PLANNING AND ZONING BOARD MEETING

City Hall – Council Chamber
405 Bagshaw Way, Edgewood, Florida
Monday, November 13, 2023 at 6:30 PM

AGENDA

- 1. Variance 2023-06: 515 Mandalay Rd. - Boat Dock
- 2. Variance 2023-07: 11 Lake Gatlin Rd. - Landscaping
- 3. Variance 2023-08: 11 Lake Gatlin Rd. - Parking
- 4. Site Plan Approval: 11 Lake Gatlin Rd.

HALL BOAT DOCK SITE PLAN - 515 MANDALAY ROAD, ORLANDO, FL 32809

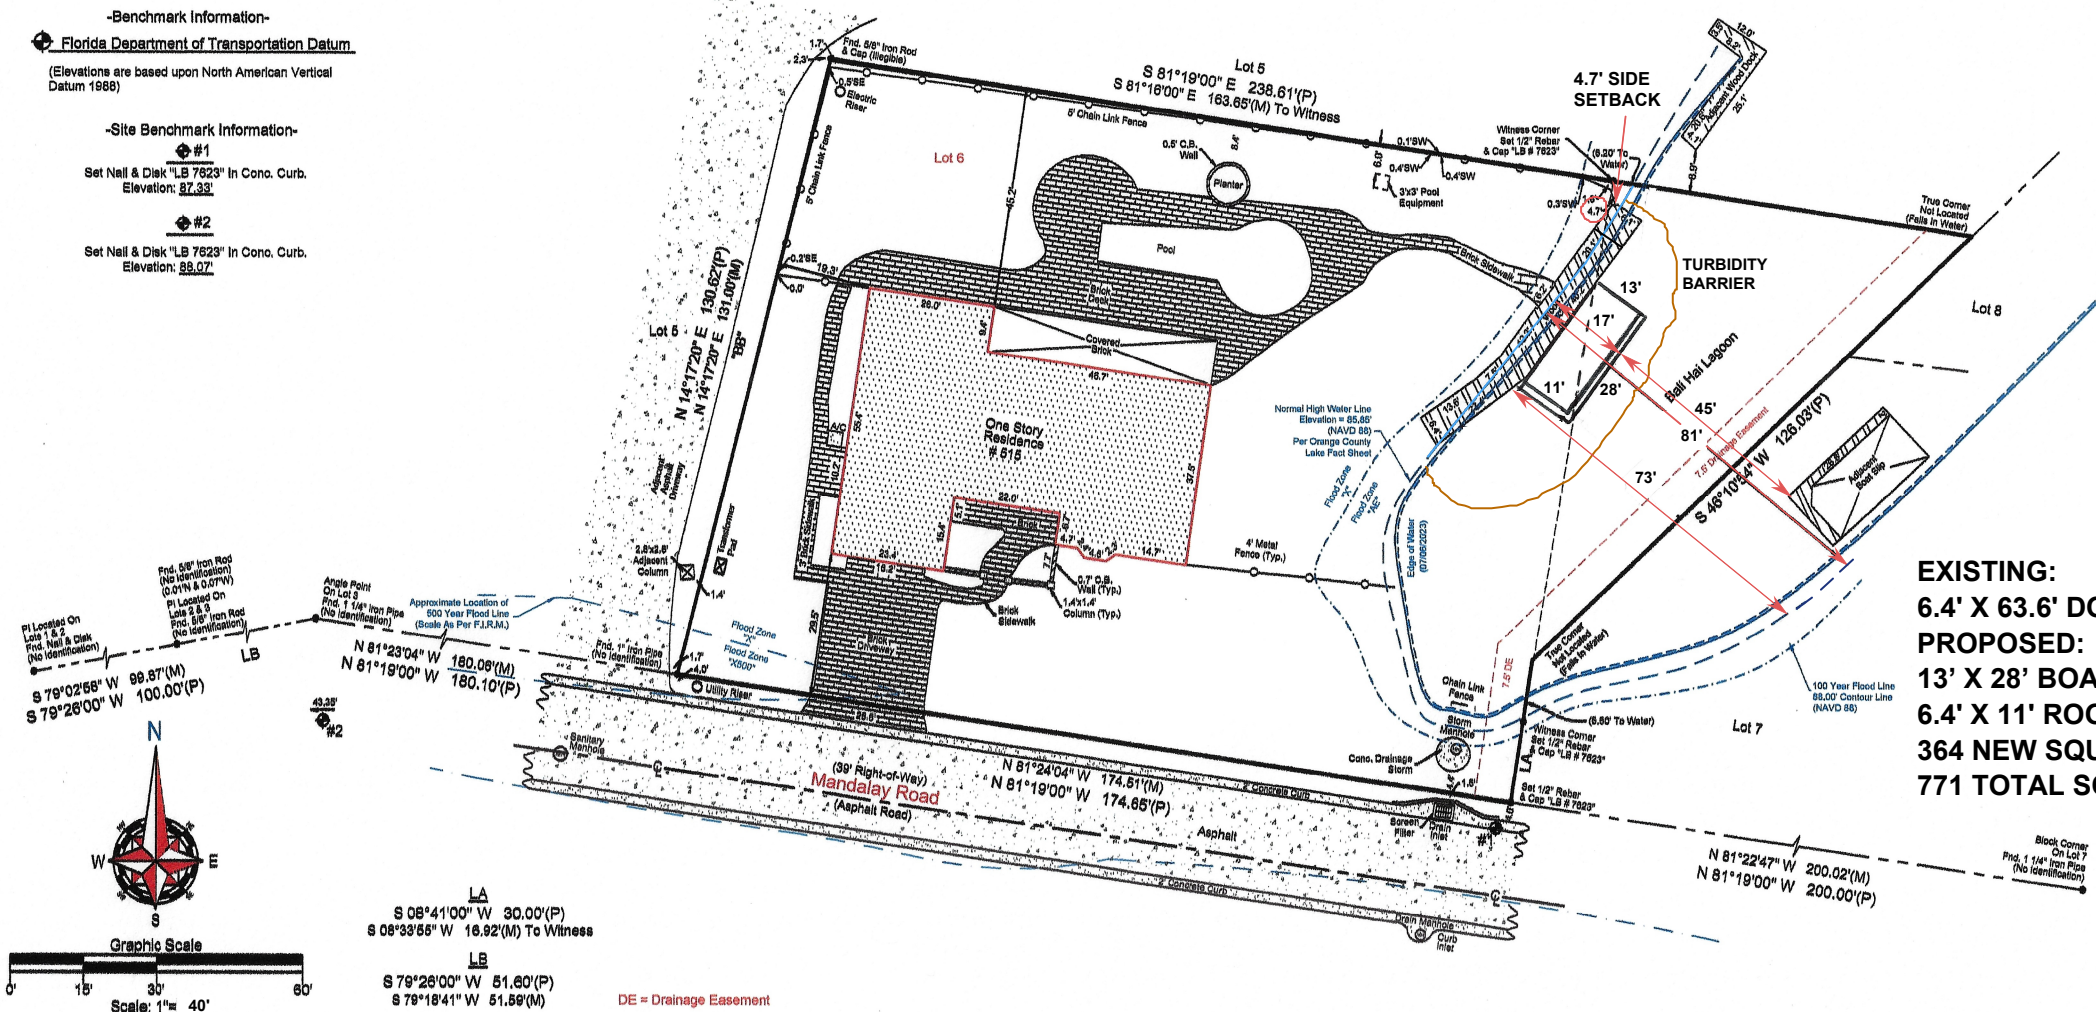
We are in receipt of the variance application addressing the location of the existing dock for the above listed address, received October 11, 2023. This property is on Bali Hai Lagoon (canal). We have reviewed the application and cover letter explaining the purpose of the request for the variance. However, the applicant did not provide a letter addressing the seven (7) variance items (letters A-H) listed on page 2 of the application.

We reviewed the application and the seven (7) items within page 2 to verify if the proposed request satisfies the application. Because the existing dock is on a canal and is constructed linearly with the canal, item A and H are non-applicable. Below is a summary of our review of items B through G from the application:

- D. The overall general welfare of the neighborhood:
CPH Review: No negative impact.
- E. Whether special conditions exist such that strict compliance with the provisions of this article would impose a unique and unnecessary hardship on the applicant:
CPH Review: The unique and unnecessary hardship will be requiring the owner to remove the portion of the dock that is encroaching in the setback.

Based on our review, we do not have any objections to the City approving this variance to allow the dock to encroach to the side setback. Please be reminded, approval of this application by the City of Edgewood does not grant authority to alter other portions of this property, nor does it waive any permits that may be required by Federal, State, or County agencies which may have jurisdiction. Applicant needs to verify if this project does not require an additional roof permit from the County.

Master Site Plan
Social Cafe @ 11 Lake Gatlin
 11 Lake Gatlin Rd, Orlando, Florida 32806

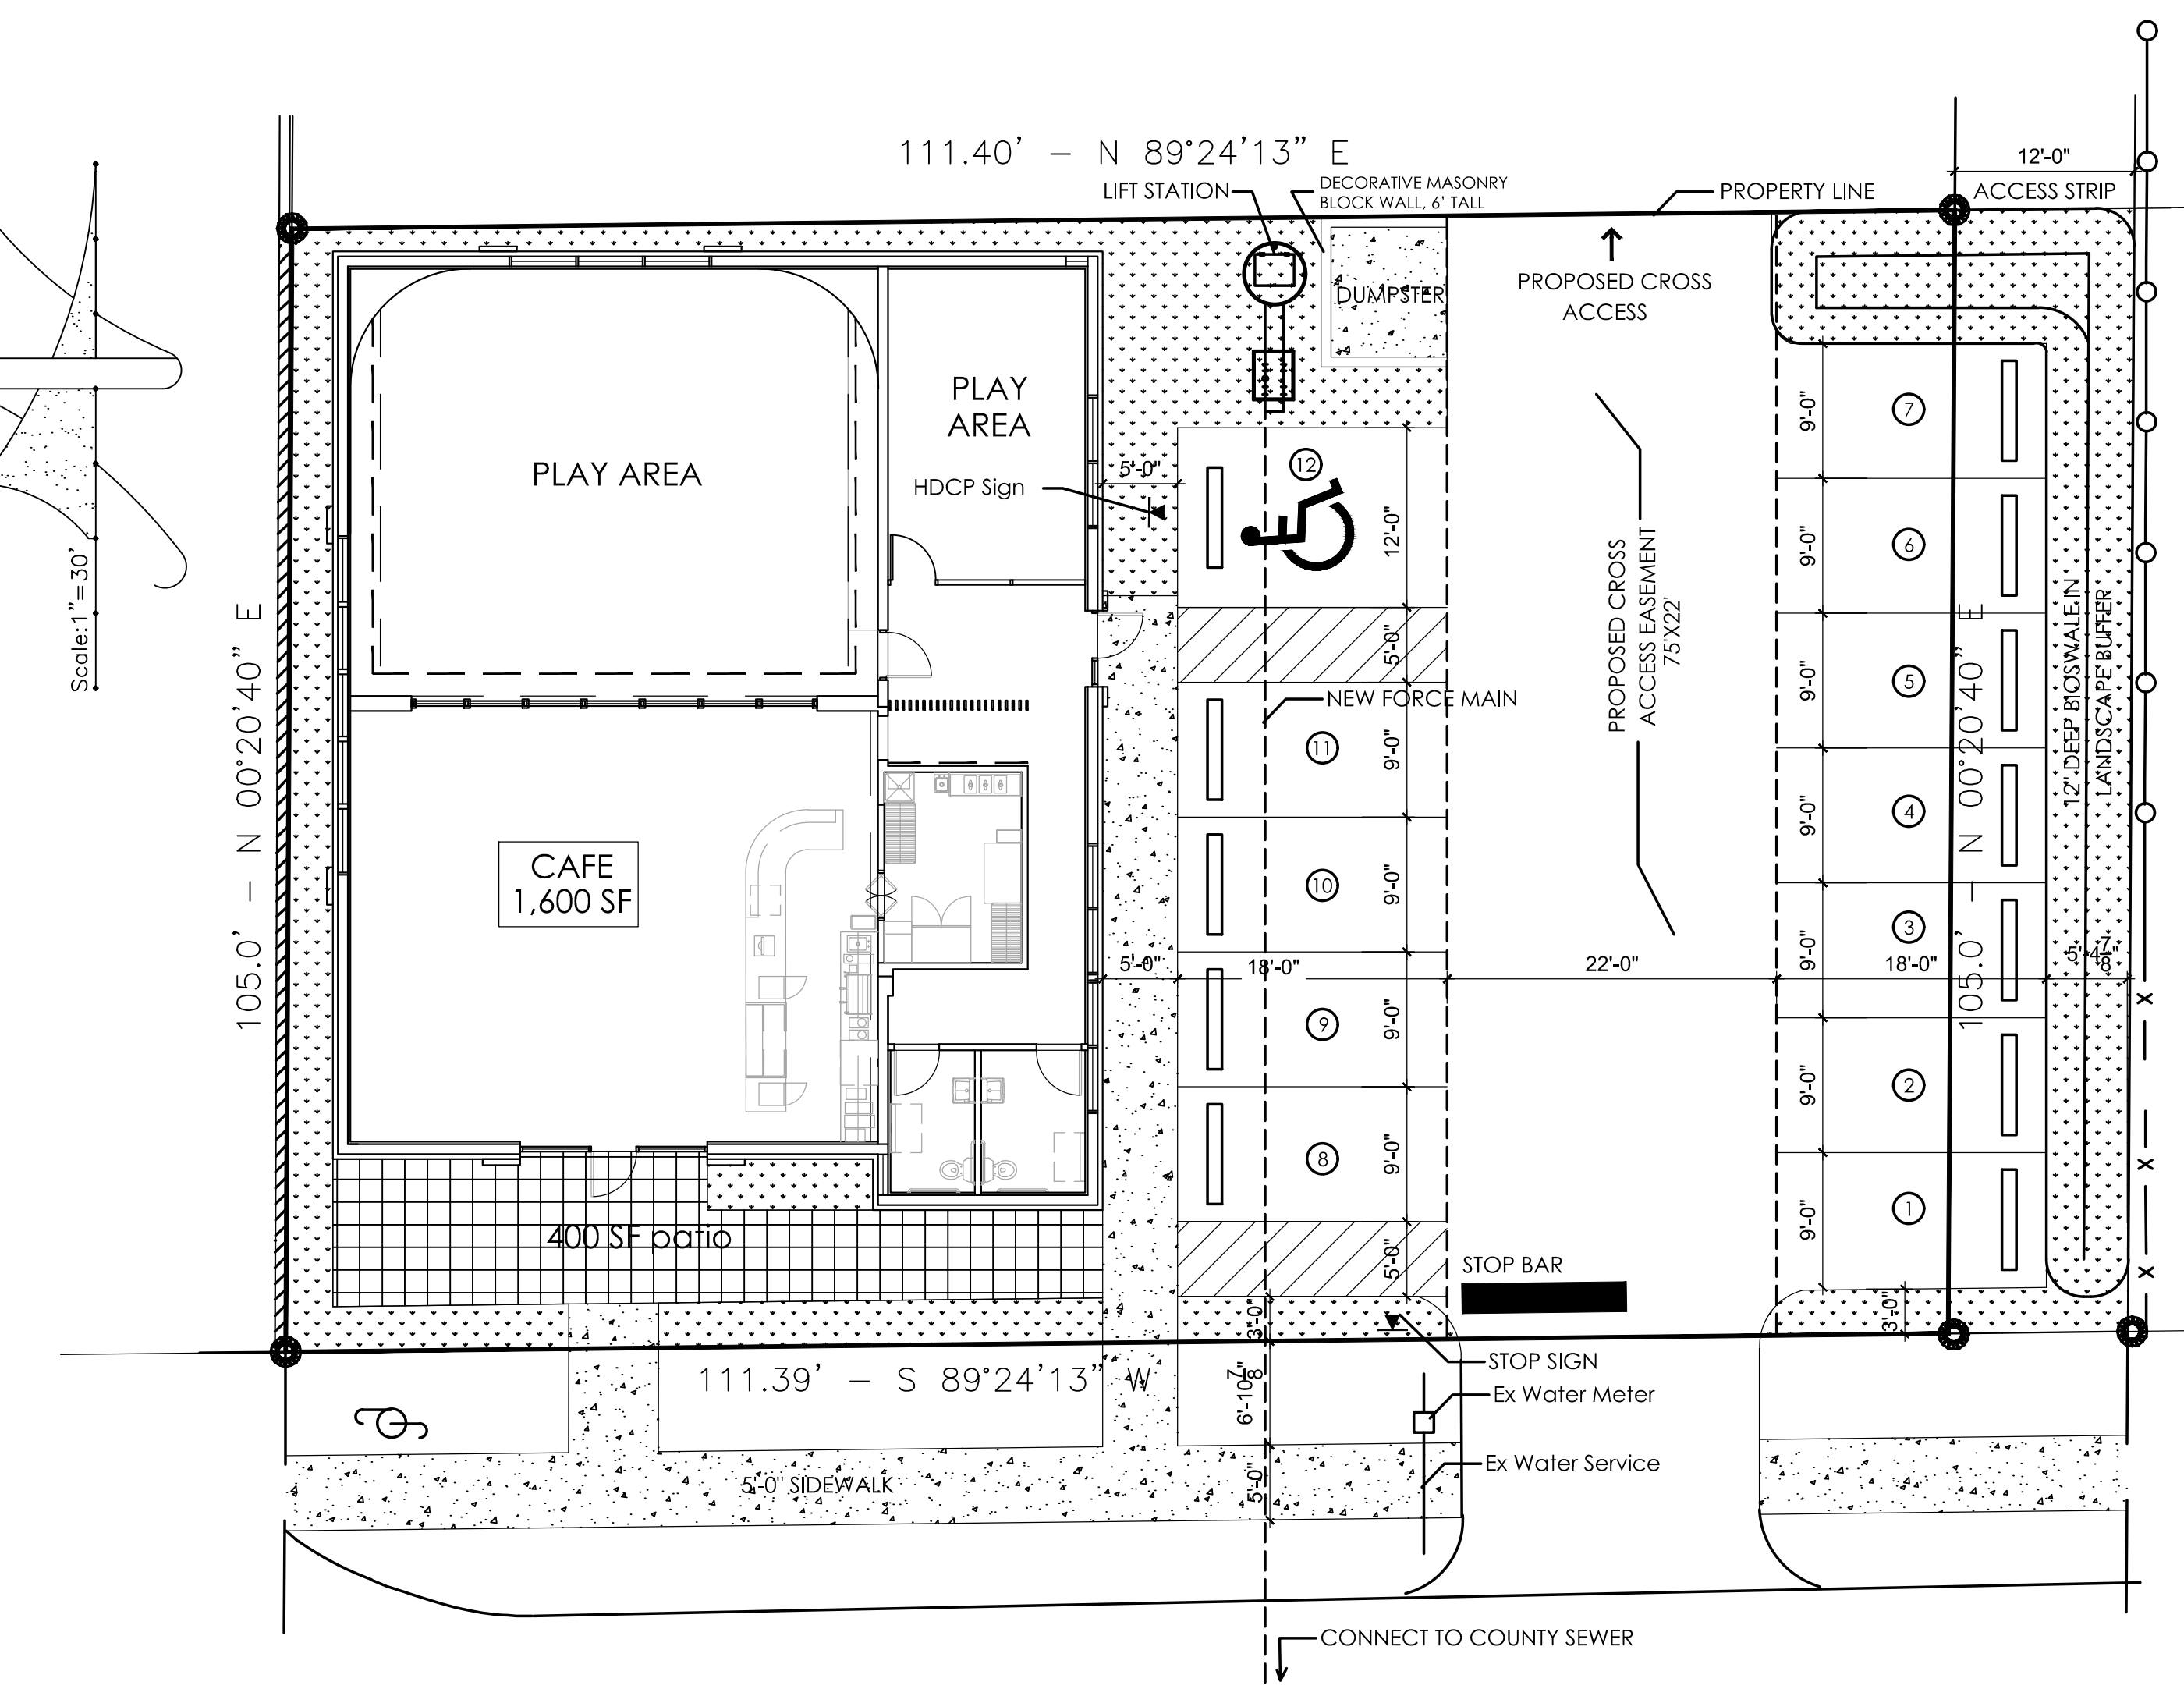
- 1) **A variance in Code Section 114-4(1)a.1 to allow the landscape buffer strip width between the parking lot and Lake Gatlin Road to be a minimum of three (3) feet in lieu of seven (7) feet.** In the existing condition, the parking lot is only three feet from the Lake Gatlin Road right-of-way line and that area is without landscape. The three-foot separation is planned to remain; thus, the variance is needed. The proposal will, though, improve the situation by providing the required landscaping. Furthermore, the applicant is proposing to move the public sidewalk south instead of adjacent to the property line to 1) provide adequate space for the required landscaping to thrive and 2) to give the impression that the minimum buffer of 7 feet width is being met. The adjacent right-of-way for Lake Gatlin Road is 60 feet wide according to Gatlin with Hobbs subdivision Misc Book 4/Page 177, which includes a 16 feet grass strip between the property line and the road pavement. Staff recommends that if this variance is approved, that it only apply to the existing development onsite; if the property is razed, compliance with current regulations should apply.

- 1) **A variance in Code Section 134-605(a)(21) to allow the parking ratio to be 1 space per 160 square feet of inside restaurant space in lieu of 1 space/100 square feet.** The site plan shows that the parking has been maximized to the extent possible, including altering the building onsite by removing the covered walkway as well as securing the use of the adjacent property: a 12 feet

wide strip. Without the strip, the potential effective parking onsite would have been only six (6) spaces. The required parking based on a 1,600 square feet café and 400 square feet of outdoor seating area is 18 spaces. The plan shows 12 spaces, including the one ADA compliant accessible space. To note, the playground that is accessory to the business does not require any parking. Staff recommends the same condition of approval mentioned above also apply to this variance should it be approved.

- 2) **A variance in Code Section 134-608(b) to allow the dimensions of the parking spaces be nine (9) feet x 18 feet in lieu of either 9 feet x 20 or 10 feet by 18 feet.** This variance is requested to maximize the width of the landscape buffer on the east side of the parking lot. As noted in requested Landscape Variance #3 above, the requested buffer width along the east side of the parking is 5 feet 4 inches instead of the required 7 feet. Without a variance in parking space length, that buffer would only be 3 feet 4 inches. The expanded buffer width will also provide the ability to create a bio-swale for stormwater management, protecting adjacent properties. The applicant is proposing the use of wheel stops to protect the adjacent landscaping/bio-swale. Staff recommends the same condition of approval mentioned above also apply to this variance should it be approved.

Master Site Plan
Social Cafe @ 11 Lake Gatlin
 11 Lake Gatlin Rd, Orlando, Florida 32806

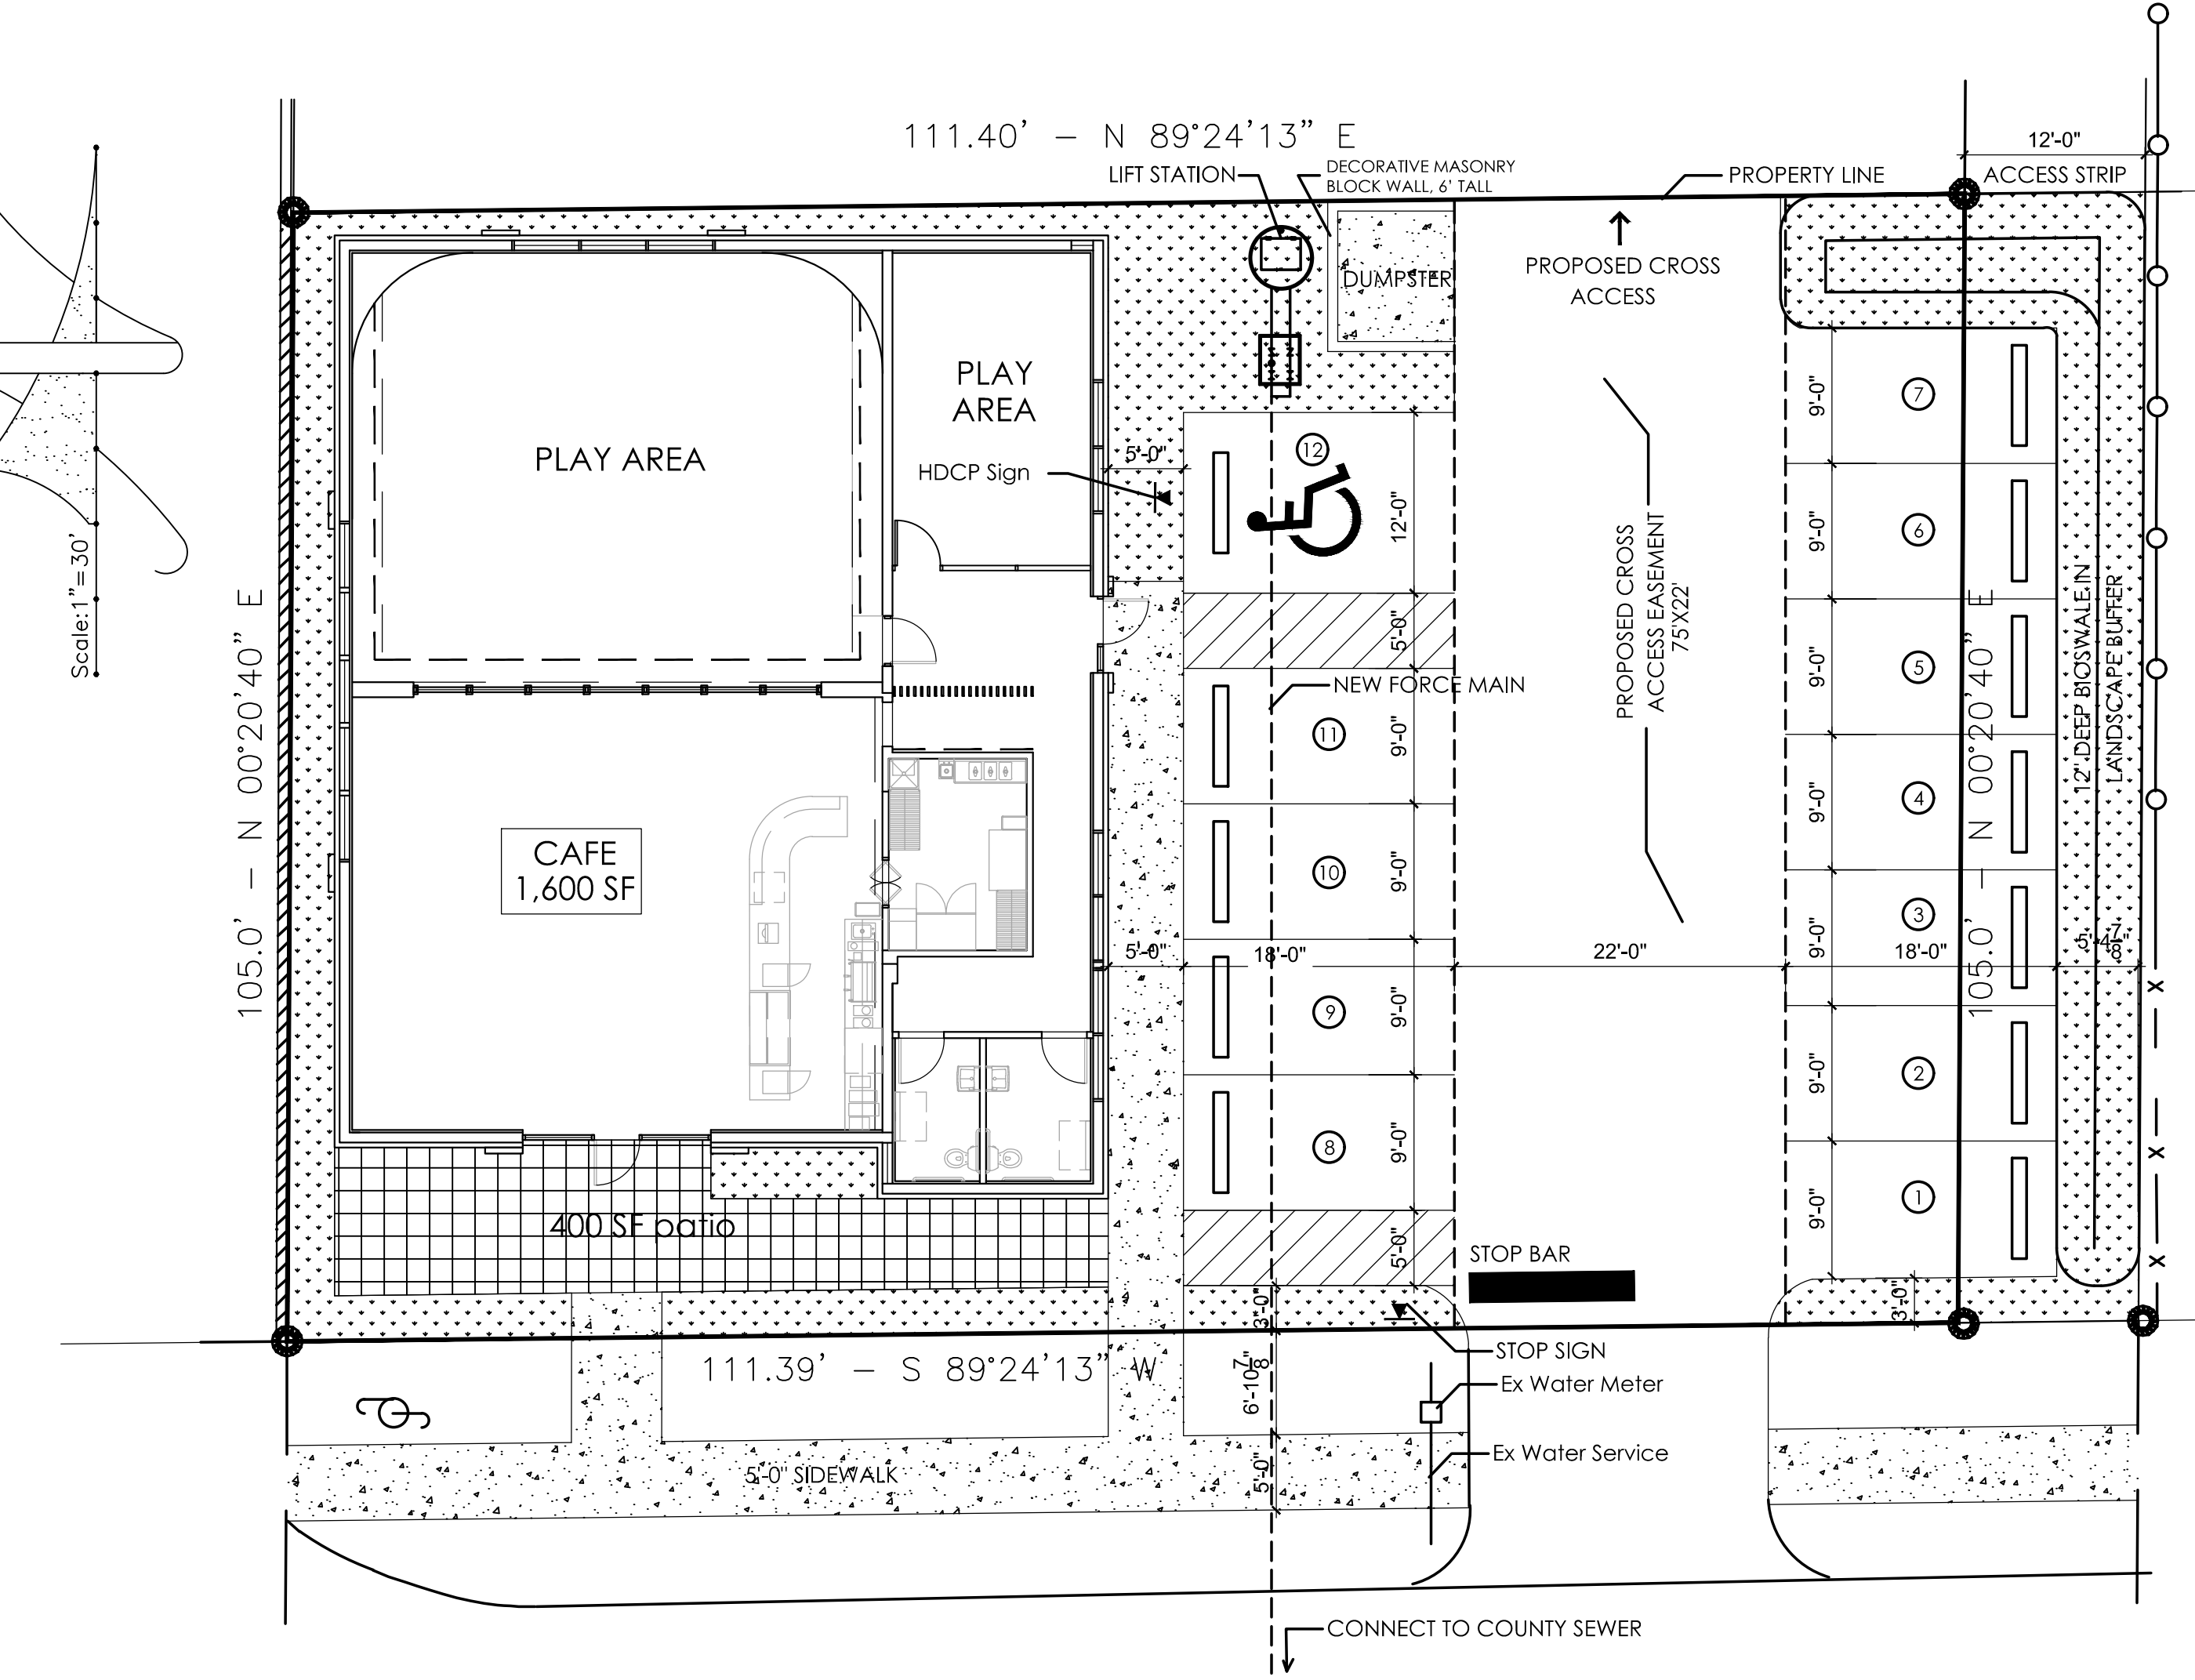
We are in receipt of the site plan, signed and sealed by Mr. Darcy Unroe, dated November 3, 2023. The plan is for the redevelopment of an existing site to provide a Café Restaurant establishment. We have coordinated our review with the City planner for setback requirements, pervious and impervious area and parking requirements. The review also included landscaping requirements and a bioretention swale for stormwater runoff treatment.

The site plan includes the layout for a new parking lot, with one ADA parking space, new sidewalks, both on site and off-site, and the location for outdoor seating. Finally, there is a proposed lift station and a dumpster location. This site will not be preparing food for cooking, so a grease trap will not be required.

Based on our review, we do not have any objections to the City approving this site plan.
